**CITY OF DELAWARE
HISTORIC PRESERVATION COMMISSION**

**HISTORIC PRESERVATION COMMISSION
MOTION SUMMARY
October 26, 2016**

2016-2532: A request by 12 West LLC for a Certificate of Appropriateness for a new building located at 14 West William Street which is zoned B-2 (Central Business District) and located in the Transitional Sub-District of the Downtown Historic District Overlay.

**Proposed Site Plan and Interior Layout
(north is toward the bottom of this page)**

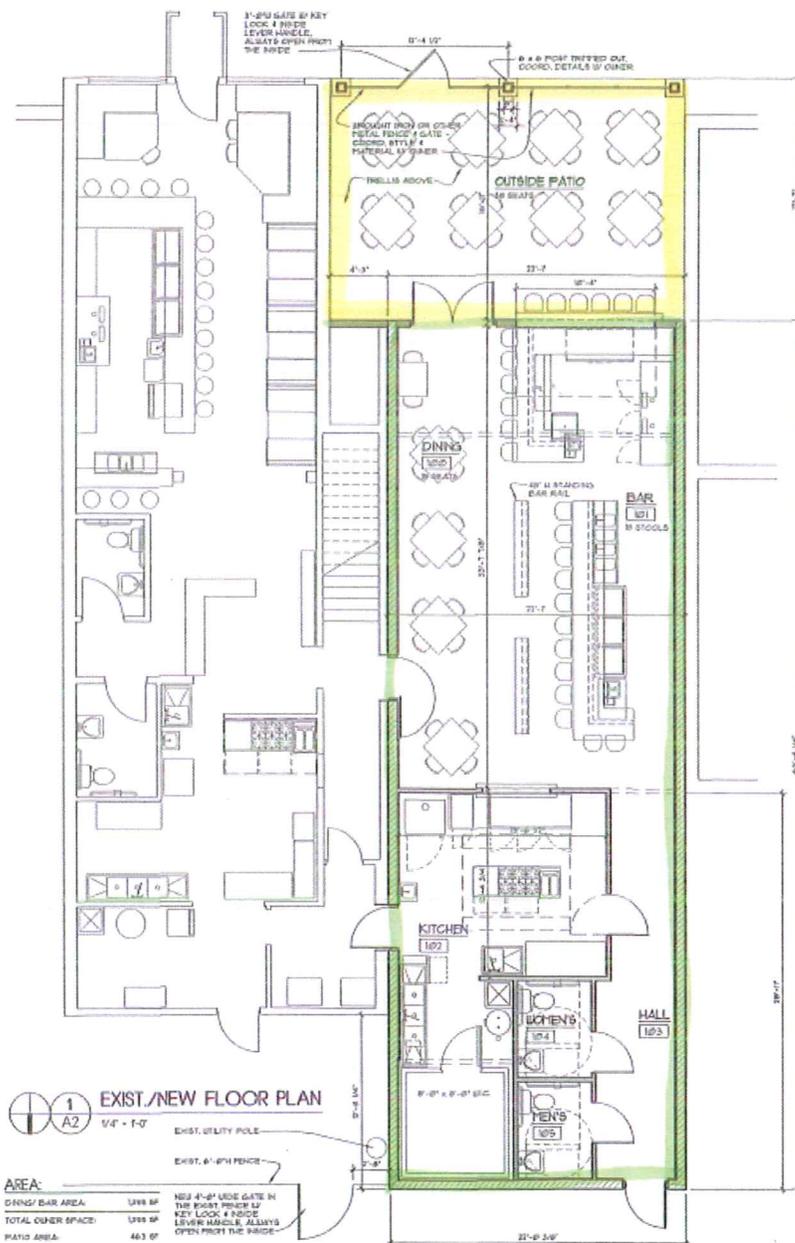
The site plan reveals the building would be setback almost 17 feet from the property line with an outdoor patio in the area between the sidewalk and building and extending to the buildings to the east and west. (The plan previously approved had a building setback of 23 feet from the property line with an outdoor patio in the area between the sidewalk and building and extending to the buildings to the east and west.) A 3 foot high black steel spindled fence will be supported by three (3) three feet high graphite-colored splitface textured block columns with a beveled stone column cap to separate the patio from the sidewalk. (Staff would suggest using a different brick face in the color and texture of the historic brick of the surrounding buildings such as face brick, quik-brik – structural brick, and cultured limestone.) An entrance gate would be located on eastern portion of the fence. (Staff would suggest that this entrance gate not be utilized as entrance gates for sidewalk patios are not utilized, generally, in the downtown. This has been acceptable by the State for liquor control approval purposes in the past. The issues Staff would note with the proposed gate configuration are that it would swing out over the City's property requiring permission and licensure for such, the gate blocks emergency services for immediate access to the site, and each patron would have to open the gate to reach the front door of the building. Alternatively, the gate should be made to swing both inside and outside and a City licensure would be required to be obtained to retain this element.) Patio flooring materials are still under discussion and should be discussed by the Commission to ensure clarity of requirements in this regard.

Proposed South (Front) Elevation – With Patio Fence

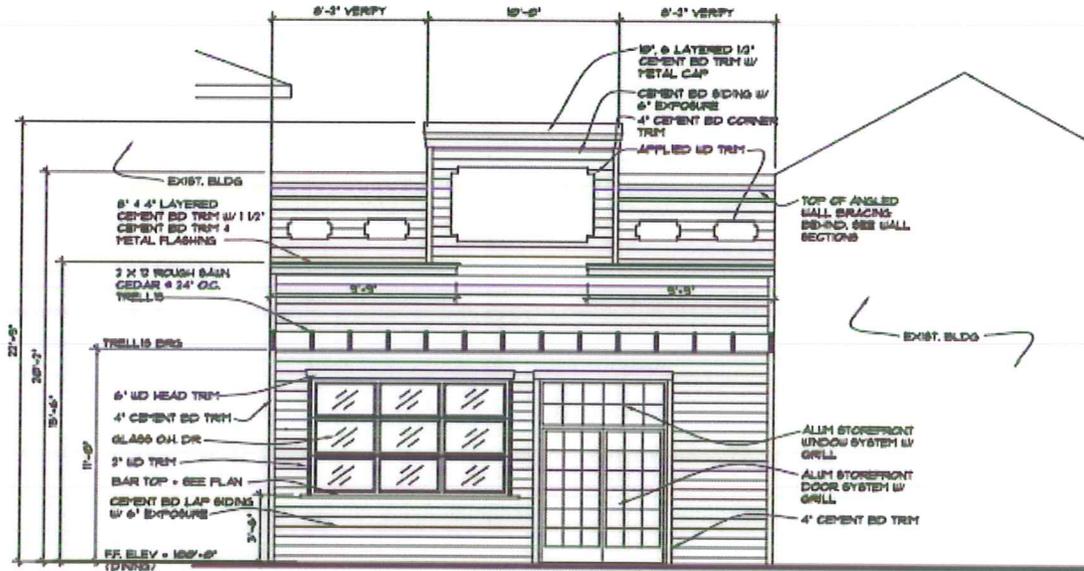
Trimmed out 6'x6' exterior grade wood columns would extend 8 feet from the three foot column caps to support a 2' x 12' rough sawn cedar trellis (at 24" on center) with cedar top trim extending over the entire outdoor patio.

The proposed color scheme is gray-tones in a combination of lighter grays SW7067 Cityscape/SW9163 Tin Lizzie and darker gray/browns SW7625 Mount Etna/SW7675 Sealskin. The specific color combination is still to be determined. The approximate 23 foot high building would be constructed of gray-toned cement lap siding with 6 inch exposure. (Staff would like to recommend a 3-1/2" or 4" exposure which may be more conducive to the time period of this building site.) A double front 27 light aluminum exterior storefront entry door with a 12-light transom will be the main entry on the east side of building front to align with the entrance gate of the patio fence. (Staff would like to recommend the entry doors be wood or wood metal-clad and glazed with at least 50% and not more than 75% glass in area according to the Architectural Standards.)

A ten foot wide bar top will be situated to the west of the entrance door to provide an open transition from the interior bar area to outdoor patio in warmer weather. A mini-glass 'overhead' rolling door will be installed in the approximate 5 foot high and 10 foot wide opening above the bar top. Six inch wide exterior wood head trim would be located above the entrance and overhead door, respectively.

Above the trellis line on the building, the building elevation would feature a dedicated sign area on the portion of the elevation that extends approximately 2.5 feet above the adjacent walls. The sign area is shown below the cornice line

and above the header trim detail. (Staff recommends the final sign design features be presented separately for review and consideration of a Certificate of Appropriateness.) The façade between the sign band and the cornice will have five wood trimmed medallions similar to those at adjacent 12 West William Street. The cornice area will be capped by a 10 foot, 6- layered ½” cement board trim with a metal cap.

3 NORTH ELEVATION
 A4 1/4" = 1'-0"

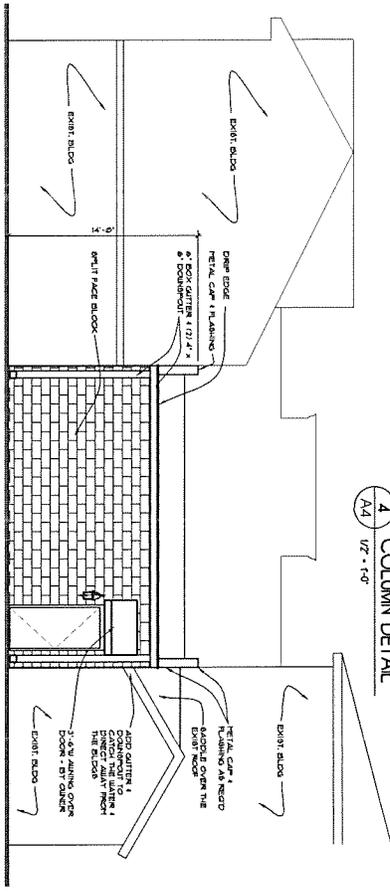
The north (rear), east (adjacent to 12 West William), and west (adjacent to 18-20 West William) elevations will be finished with the same graphite-colored splitface textured block found on the front patio fence columns. (Staff would suggest using a different brick face in the color and texture of the historic brick of the surrounding buildings such as face brick, quik-brik – structural brick, and cultured limestone.) A flush metal service entry door, painted to match a proposed shed-type fabric awning, will be located on the north (rear) elevation. Because of the size and design of the adjacent buildings, about 13 feet of the east elevation (rear portion) would be exposed to the public and approximately 48 feet of west elevation (front and rear) would be exposed to the public. Due to Building Code requirements, no openings are allowed in this exposed rear portion of the side elevations.

1 **EXIST./NEW FLOOR PLAN**
A2 1/4" = 1'-0"

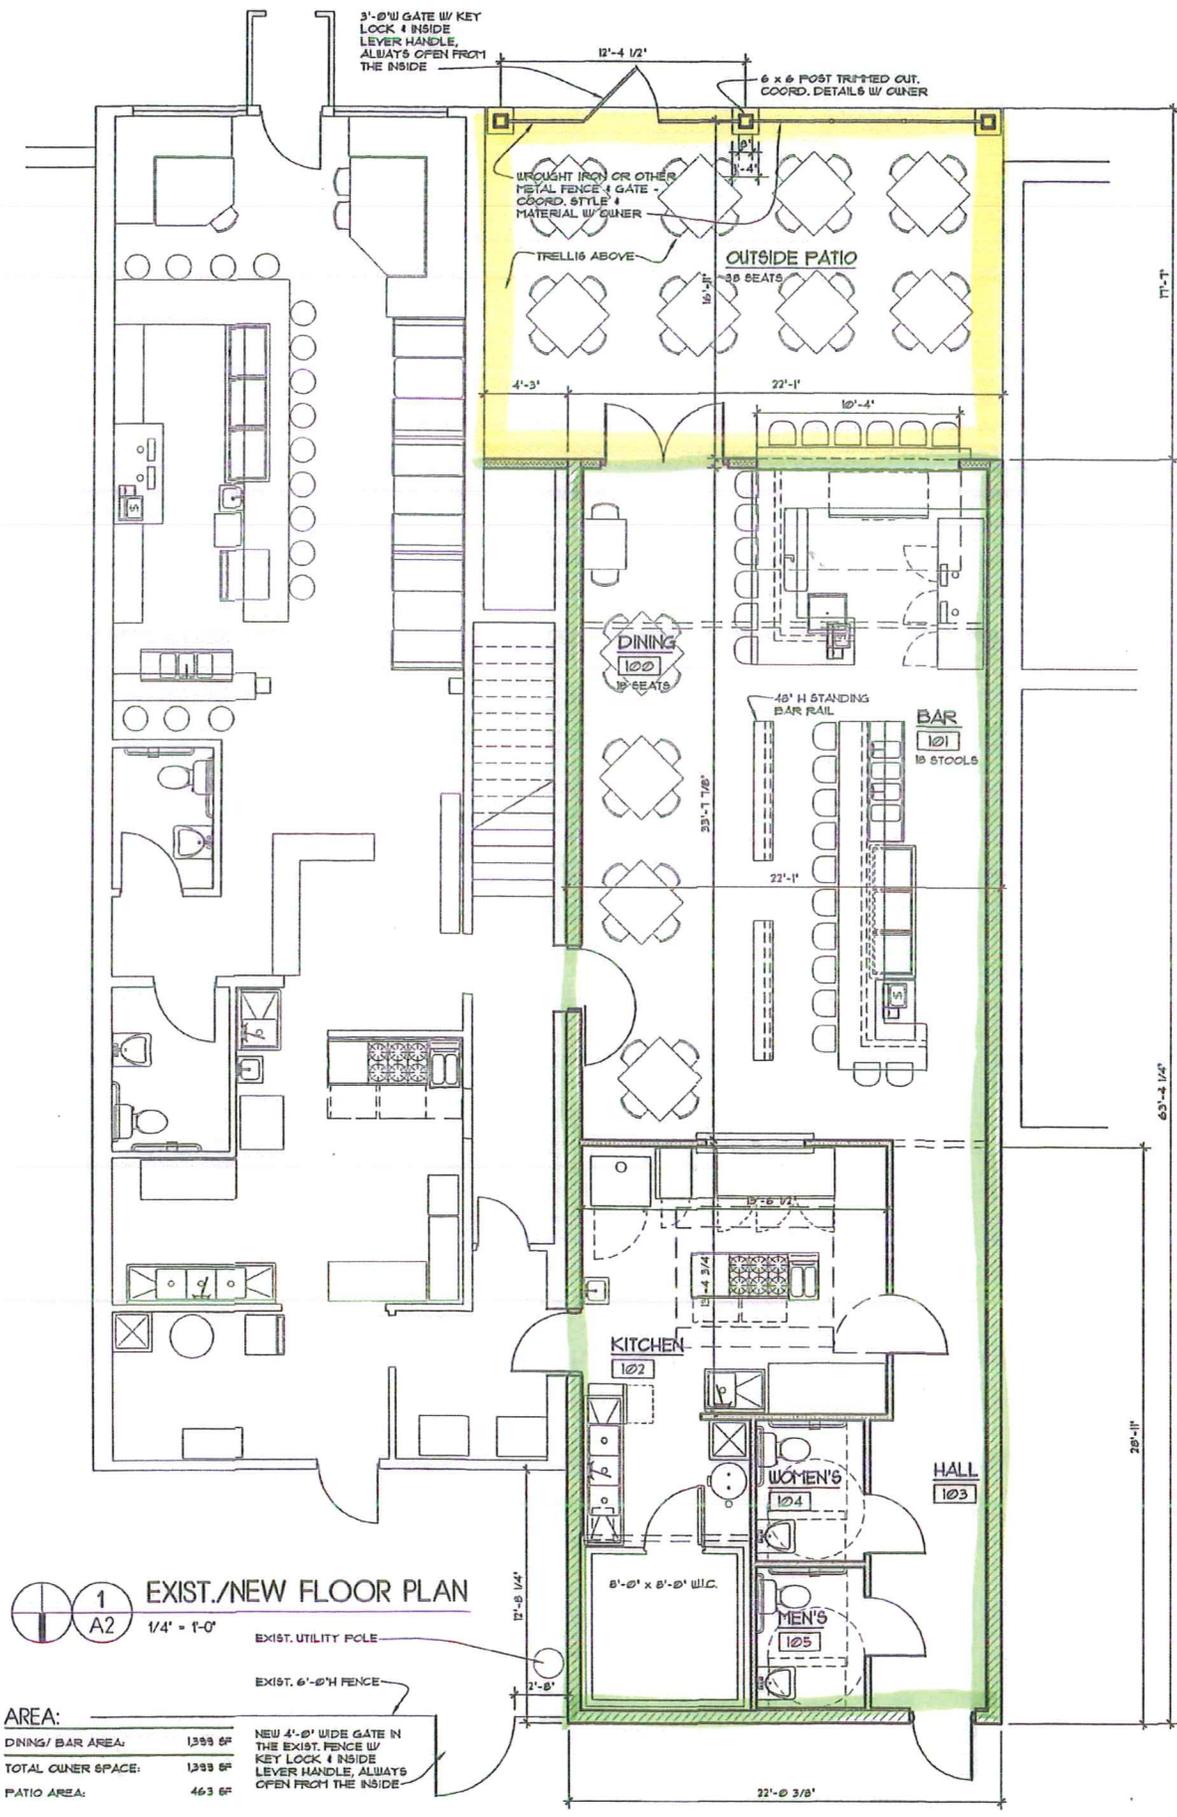
NEW 4'-0" WIDE GATE IN THE EXIST. FENCE W/ KEY LOCK & INSIDE LEVER HANDLE, ALWAYS OPEN FROM THE INSIDE

- 5) The fence gate proposed shall either be eliminated or shall require separate review and consideration by the City in order to allow it to swing over the City right-of-way. The Applicant is required to approach the State of Ohio liquor control agency to attempt to have this removed to facilitate safety force access to the front of the structure.
